Vermont Gas Systems, Inc. - Addison Natural Gas Project- Phase I
 Vermont Wetland Permit Amendment
 Williston to Middlebury, Vermont
 Adjoining Property Owners
 Prepared by: VHB
 December 20, 2012
 Last Revised: December 16, 2015

VGS Addison Natural Gas Project (ANGP) - Phase I
Summary of Project Revisions for Vermont Wetland Permit Amendment
Prepared by VHB
December 16, 2015

ADDISON NATURAL GAS PROJECT TRANSMISSION MAINLINE

8 Open Trench Stream Crossing - Typical Section 04/13
N.T.S. Source: VHB

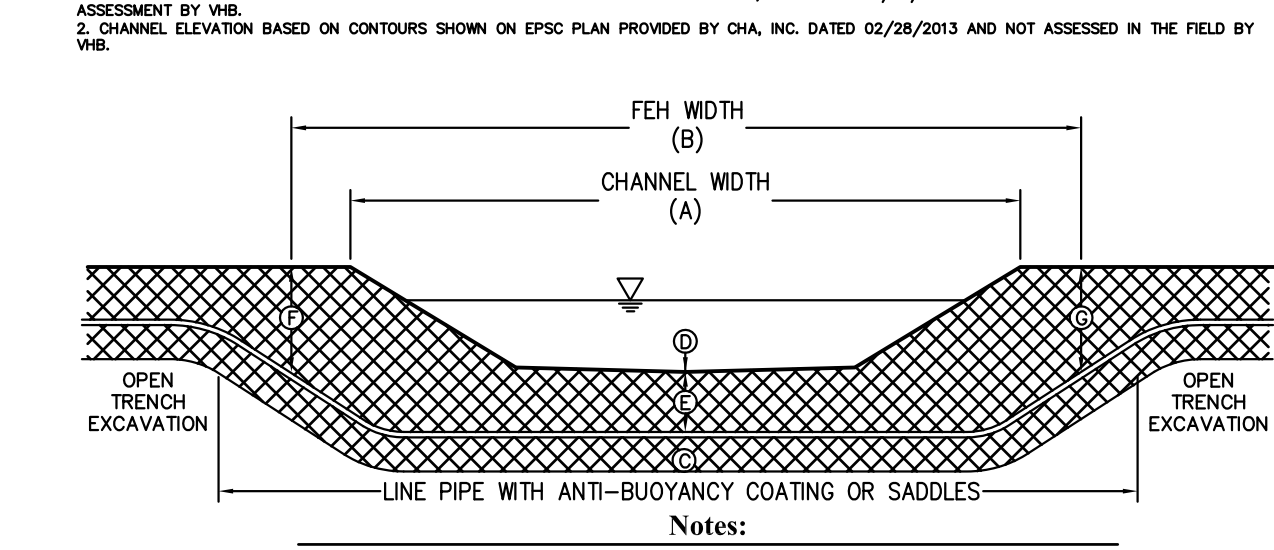
DWG. NO.		REFERENCE DWG.		DESCRIPTION		INITIALS		DATE		YEAR: 2015		W.O.		SCALE: NOTED		DWG. ANGP-T-G-017		REV. 2	
2	BCK	TDB	VHB EDITS (12/10/15)	1	BCK	TDB	VHB EDITS (6/09/15)

ANGP-T-C-050	ALIGNMENT SHEET	1	BCK	TDB	ROTAX ROAD REROUTE (10/26/15)	ENVIRONMENTAL	JLS	06/28/13	JLS	04/02/15	VERMONT GAS PROPOSED 12" PIPELINE ADDISON NATURAL GAS PROJECT EPSC PLAN			
DWG. NO.	REFERENCE DWG.	REV	DSN	CK	DESCRIPTION	INITIALS	DATE	INITIALS	DATE	YEAR: 2015	W.O.	SCALE: 1" = 100'

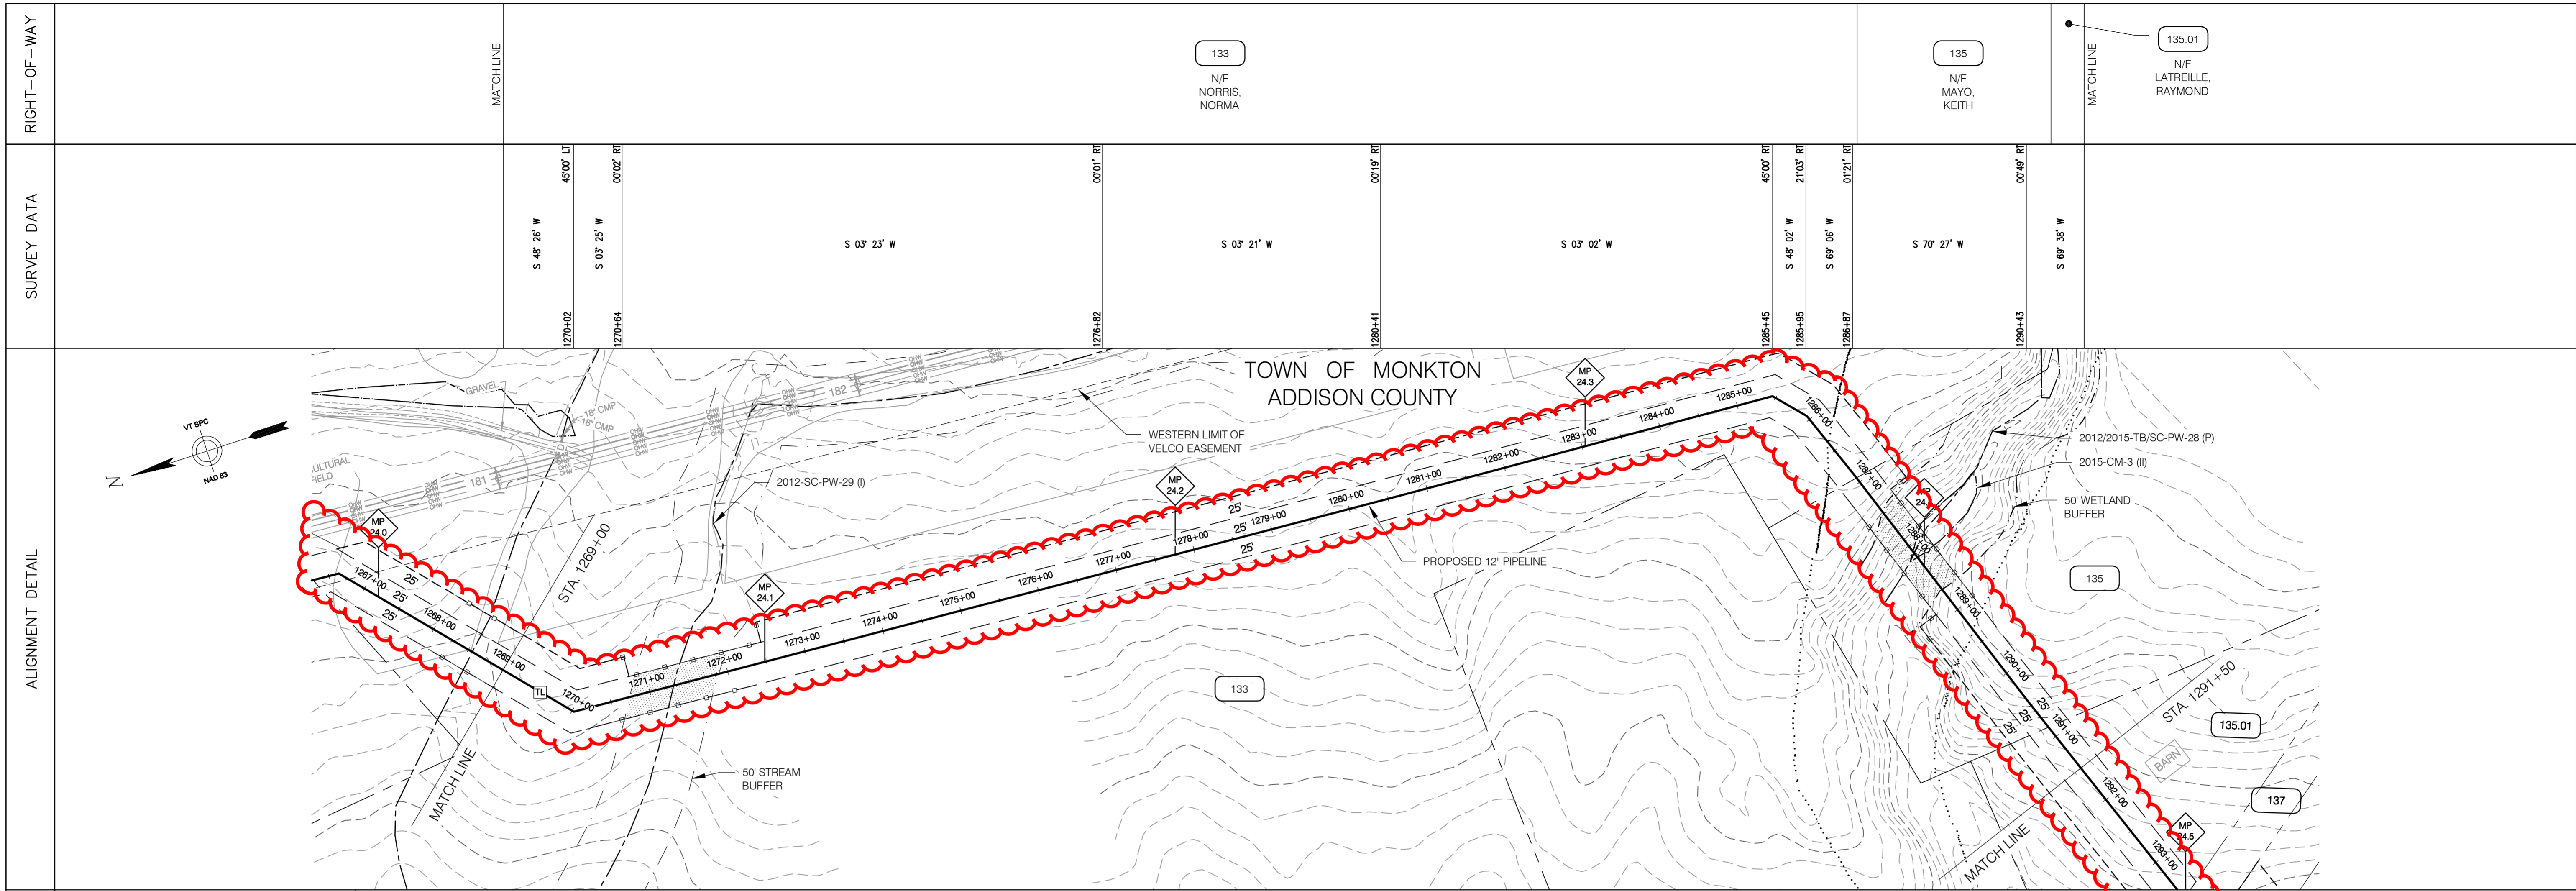
Description of Change	Wetland Feature ID	Town	VHB Natural Resource Map Series #	CHA EPSC Sheet #	Revised Impact Exhibit #	Landowners (s) (LLN #)	Wetland Impacts			Wetland Buffer Impacts		
							Previously Permitted Wetland Impact Area (sq. ft.)	Proposed Amendment Wetland Impact Area (sq. ft.)	Change in Wetland Impact Area (sq. ft.)	Previously Permitted Wetland Buffer Impact Area (sq. ft.)	Proposed Amendment Wetland Buffer Impact Area (sq. ft.)	Change in Wetland Buffer Impact Area (sq. ft.)
Realign approximately 3,400 feet of pipeline from station 1266+55 to 1301+00 using open trench construction for the entire distance in the vicinity of Rotax Road	2013-CM-3	Monkton	21, 22	ANGP-EPSC-051	-	134 (Norris), 134.05 (Palmer), 137 (Town of Monkton)	7,423	0	-7,423	7,804	0	-7,804
	2014-CM-3	Monkton	22	ANGP-EPSC-051	82 through 84	138 (Latreille), 140 (Bailey)	2,786	2,167	-619	1,693	1,759	66
	2015-CM-3	Monkton	21, 22	ANGP-EPSC-050	78	135 (Mayo)	0	532	532	0	5,452	5,452

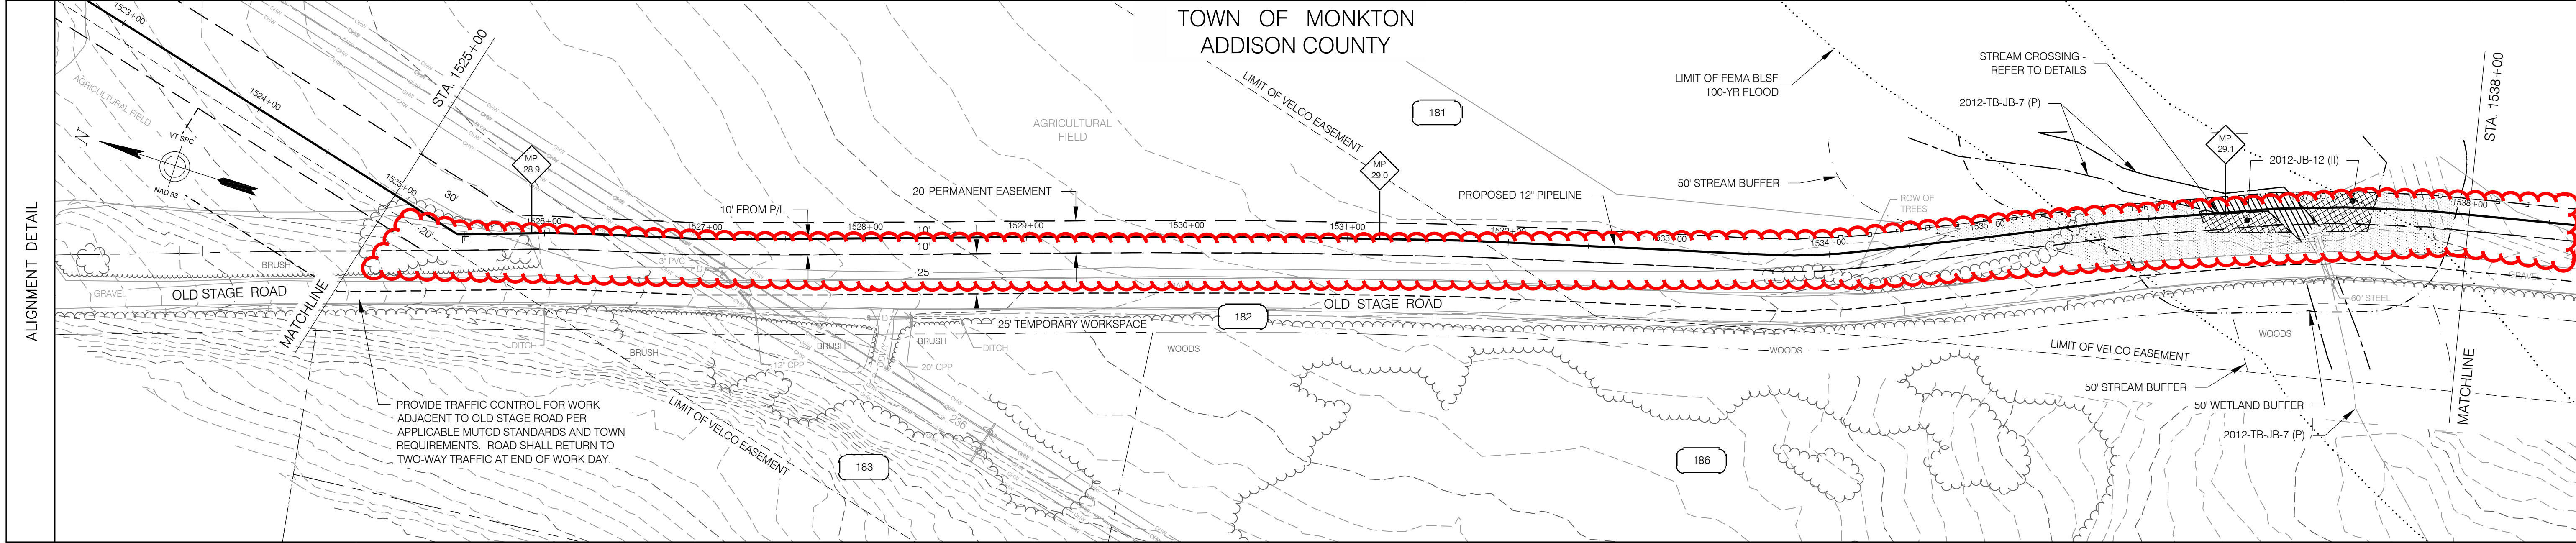
Adjust pipeline route along Old Stage Road to align with surveyed road ROW.	2012-JB-12	Monkton	25	ANGP-EPSC-061A	97	181 (Hurlburt)	267	318	51	920	902	-18
Remove Access Road AL. Modify ATWS adjacent to corridor. Add Access Road BK. Replace approximated natural resource data with field delineated data.	Previous ID 2013-AW-RS-29 Feature ID 2015-MJ-1	Monkton	27	ANGP-EPSC-065	-	196, 197 & 197.01 (Lichtenburg & Delictii)	1,514	0	-1,514	907	0	-907
							Summary of Class II Wetland Impact Change (sq. ft.)		-8,973	Summary of Wetland Buffer Impact Change (sq. ft.)		-3,211

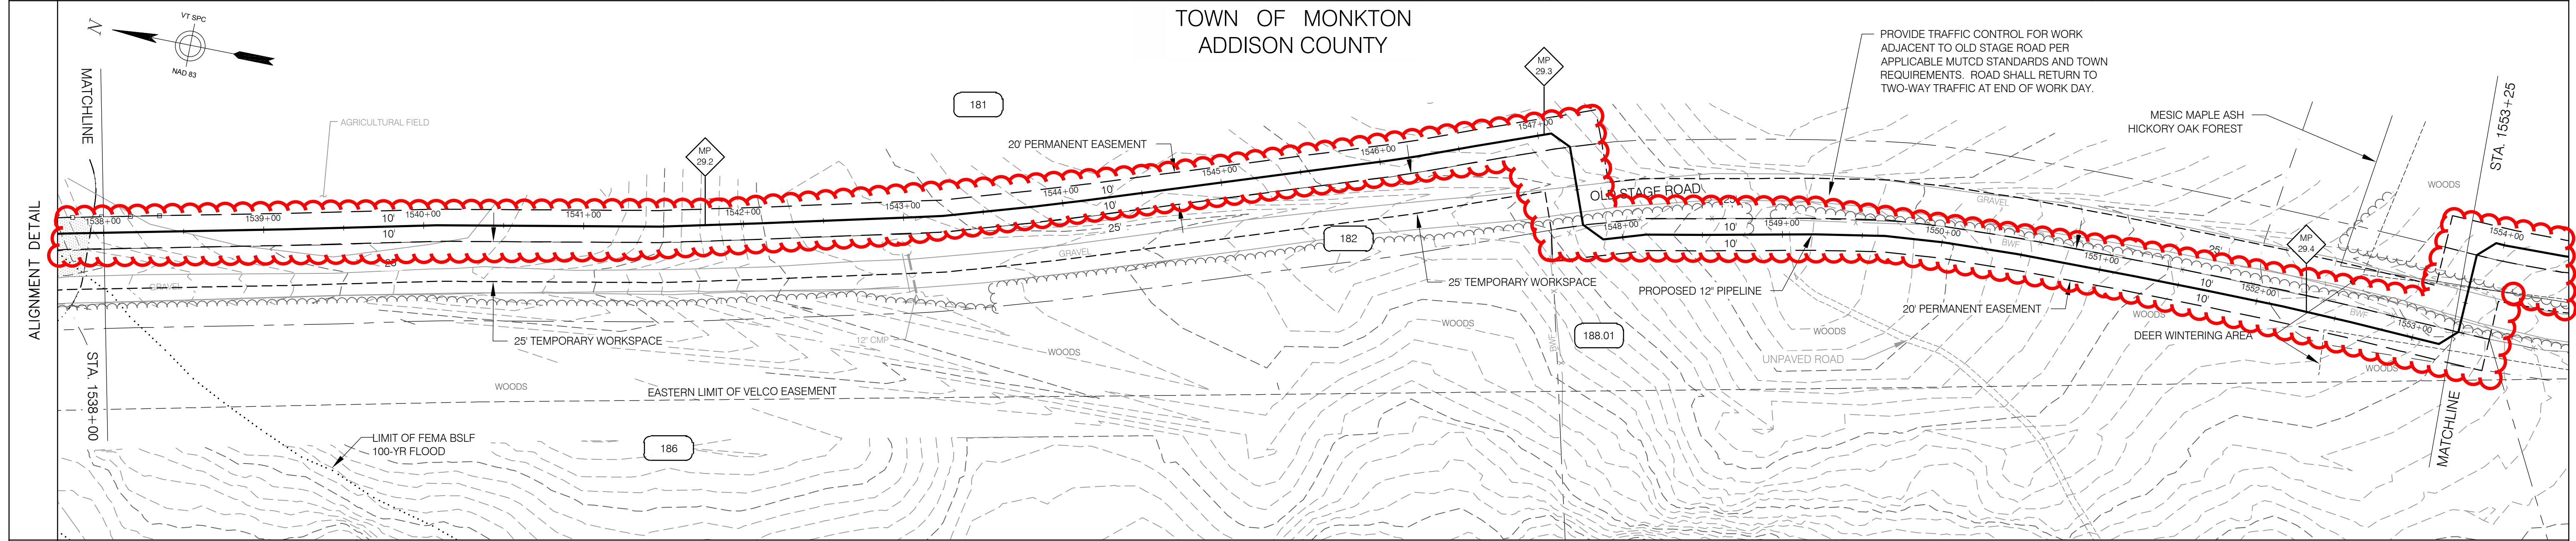
ANGP-T-C-061B	ALIGNMENT SHEET	1	VGS	VGS	OLD STAGE ROAD RE-ROUTE (11/13/15)	DESCRIPTION	INITIALS	DATE	INITIALS	DATE	YEAR: 2015	W.O.	SCALE: 1" = 50'	DWG. ANGP-EPSC-061B	REV. 1
---------------	-----------------	---	-----	-----	------------------------------------	-------------	----------	------	----------	------	------------	------	-----------------	---------------------	--------

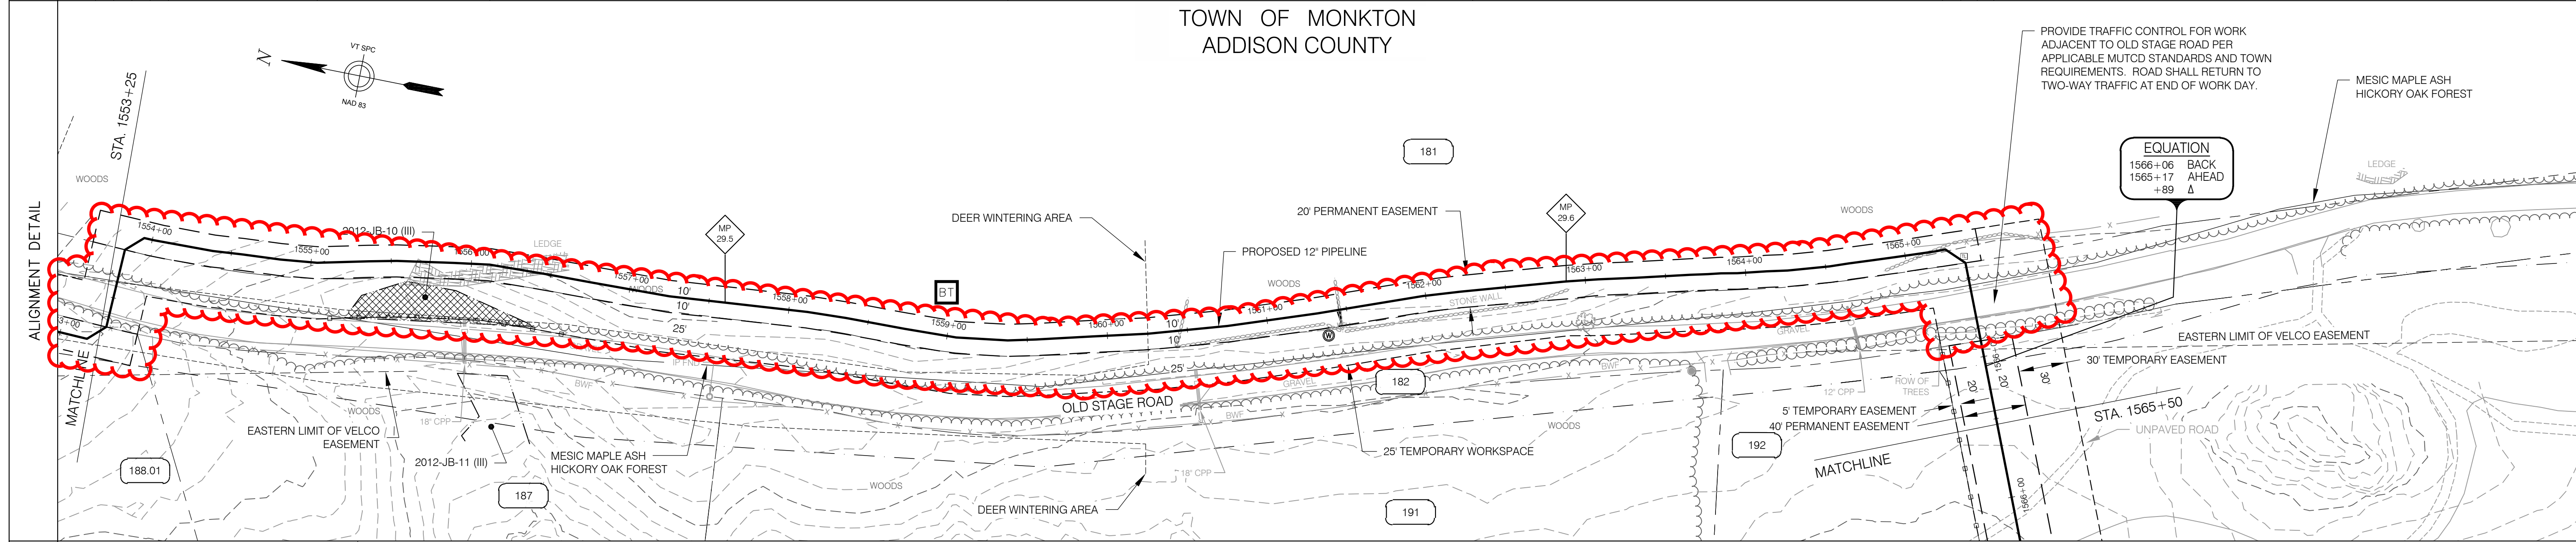
ANGP-T-C-062	ALIGNMENT SHEET	1	VGS	VGS	OLD STAGE ROAD RE-ROUTE (11/13/15)	ENVIRONMENTAL	JLS	06/28/13	JLS	04/02/15	VERMONT GAS PROPOSED 12" PIPELINE ADDISON NATURAL GAS PROJECT EPSC PLAN	Vermont Gas	38 Eastwood Drive, Suite 105 South Burlington, VT 05403 Main: (802) 735-0372 • www.chacompanies.com
DWG. NO.	REFERENCE DWG.	REV	DSN	CK	DESCRIPTION	DRAFTING DESIGNER	GIL	06/28/13	GIL	04/02/15			
						DRAFTING SUPERVISOR	BZD	06/28/13	BCK	04/02/15	YEAR: 2015	W.O.	REV. 1
						DESIGN ENGINEER	MDF	06/28/13	TDB	04/02/15			
						DESIGN MANAGER	SAB	06/28/13	JEO	04/02/15
